**MANDATORY BULLETIN No. EV 97-042a SR R1
SAFETY RELATED**

- 1. CONCERNING:** All EV-97 EuroStar airplanes.
- 2. REASON:** Unification of the strength class of the fastening bolts in the joint of the engine and the engine mount hinges and the resulting minimization of the possibility that these bolts will be accidentally interchanged.
- 3. REQUIRED ACTIONS:**
 1. Replace the fastening bolts in accordance with the bulletin text.
 2. Record the replacement in the Aircraft Logbook.
- 4. LATEST DAY OF THE ACTION:** Within 30 calendar days of the issue of this bulletin or during the next scheduled service inspection, whichever occurs first.
- 5. CARRIED OUT BY:** Organizations authorized for maintenance / repairs of this type of airplane.
- 6. COSTS COVERED BY:** Airplane owner/operator.
- 7. NECESSARY MATERIAL:** In accordance with the bulletin text.
- 8. WORK PROCEDURE:** In accordance with the bulletin text.
- 9. APPENDICES:** None.

Valid from: August 7th, 2023

Fig. 1 – Securing the engine against falling

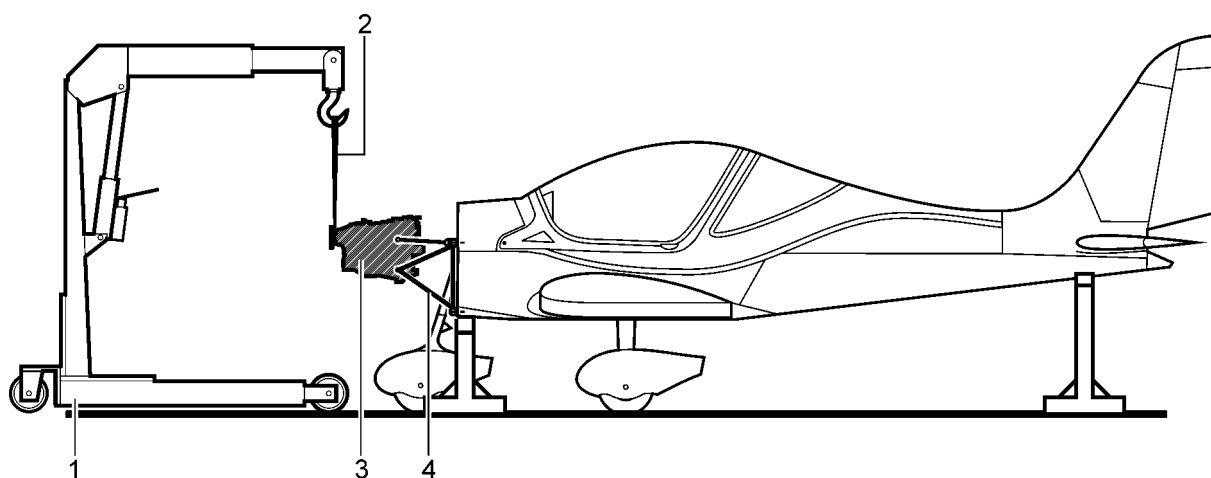
- 1.3.1.7 Remove any hoses or devices that prevent access to the bolts of the engine on the engine mount hinges. In case of removal of one of the hoses, make sure to drain its contents.
- 1.3.1.8 Secure the ends of the removed hoses with suitable plugs against the ingress of dirt.
- 1.3.1.9 Hang the engine (3, Fig. 1) on the workshop crane (1) using the suspension strap (2). The engine (3) is now secured against falling.
- 1.3.1.10 Remove the cotter pins and plugs (5, 7, Fig. 3) from the bolts (1, 2, 3, 4, Fig. 2) in the joint of the engine and the engine mount hinges.

- 1.3.1.21 Release the engine from the mounting crane (Fig. 1).
- 1.3.1.22 Remove all plugs from hoses or devices.
- 1.3.1.23 Attach all hoses which were previously removed to gain access to the bolts.

Fig. 2 – Engine mount – position of fastening bolts

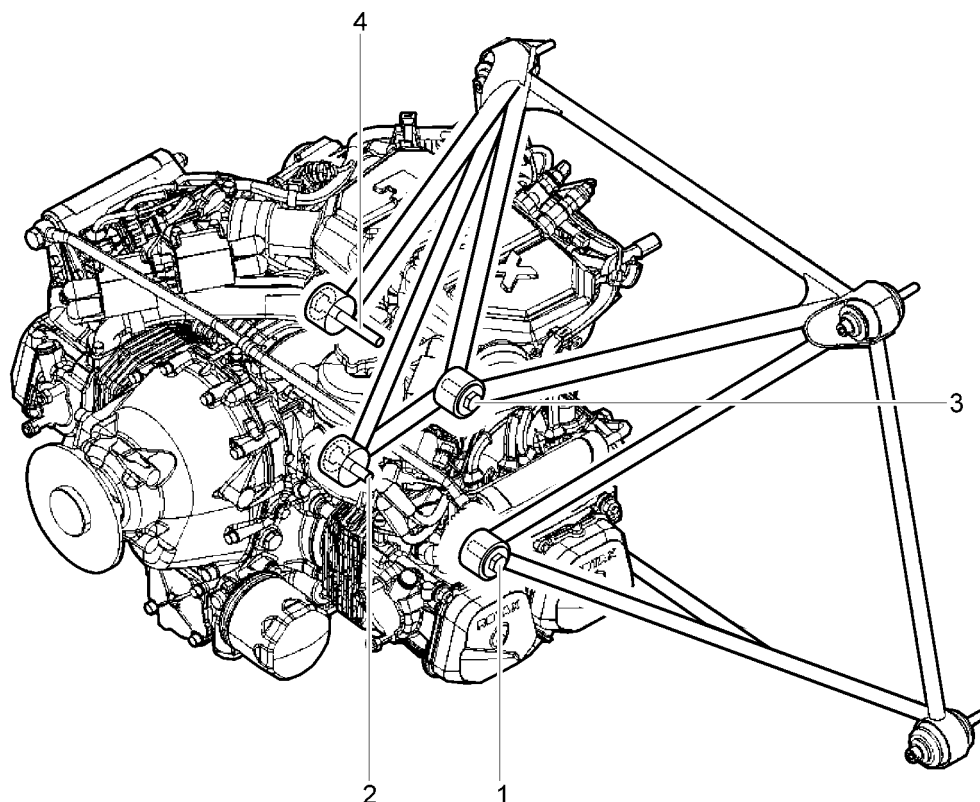
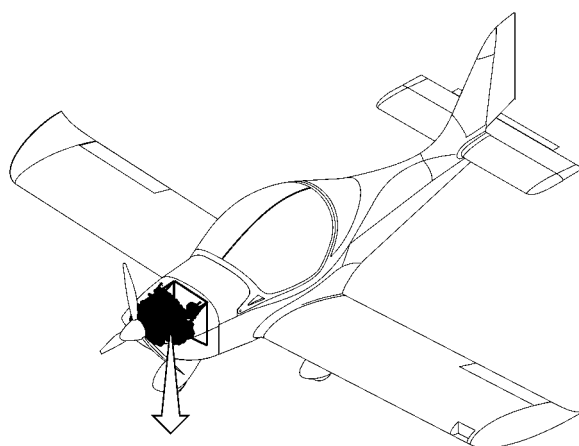
- 1.3.1.11 Remove the bolt (1) from the joint of the engine and the engine mount hinges. Immediately replace the removed bolt with a **new** bolt and a **new** washer (6, Fig.3) and tighten it lightly.

- 1.3.1.12 Remove the bolt (2) from the joint of the engine and the engine mount hinges. Immediately replace the removed bolt with a **new** bolt and a **new** washer (6, Fig.3) one and tighten it lightly.

- 1.3.1.13 Remove the bolt (3) from the joint of the engine and the engine mount hinges. Immediately replace the removed bolt with a **new** bolt and a **new** washer (6, Fig.3) and tighten it lightly.

- 1.3.1.14 Tighten the bolt (4, Fig. 2) in the joint of the engine and the engine mount hinges using a torque wrench with a torque of 40 Nm. This bolt is the only one that is not replaced, but the tightening torque value is changed from 35 Nm to 40 Nm.

- 1.3.1.15 Tighten the bolts (1,2,3) in the joint of the engine and the engine mount hinges using a torque wrench with a torque of 40Nm.
- 1.3.1.16 Put the plugs (5, Fig.3) on the bolts (4), (1,2,3,4, Fig.2).

*Fig. 3 – Engine suspension*

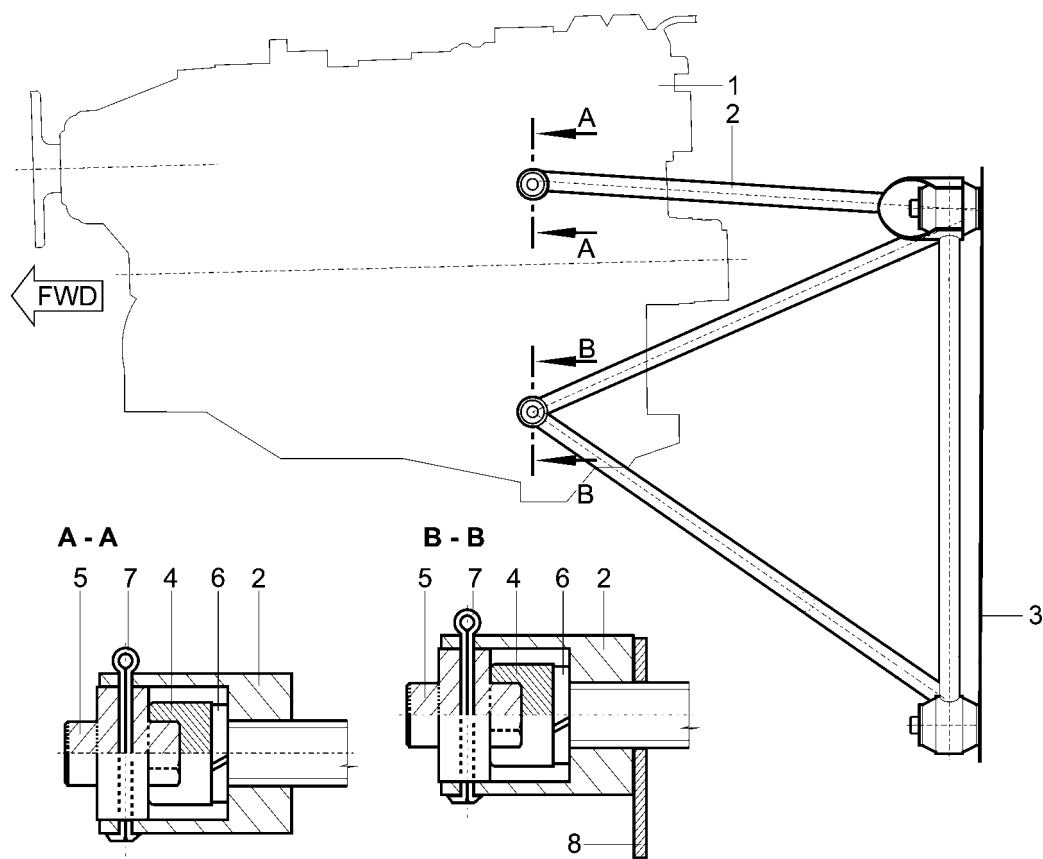
- 1.3.1.17 Mark the plugs (5, Fig. 3) with a marking pin in accordance with the holes in the engine mount hinges (2) on both sides.
- 1.3.1.18 Remove the plugs (5) from the bolts (4) and drill through them with a $\varnothing 2,1$ mm drill bit in accordance with the marks made by the marking pin.

- 1.3.1.19 Put the plugs (5) back on the bolts (4) so that they align with the holes in the engine mount hinges (2).
- 1.3.1.20 Use the cotter pins (7) to secure the bolts (4) with the plugs (5) in the joint of the engine and the engine mount hinges (2).
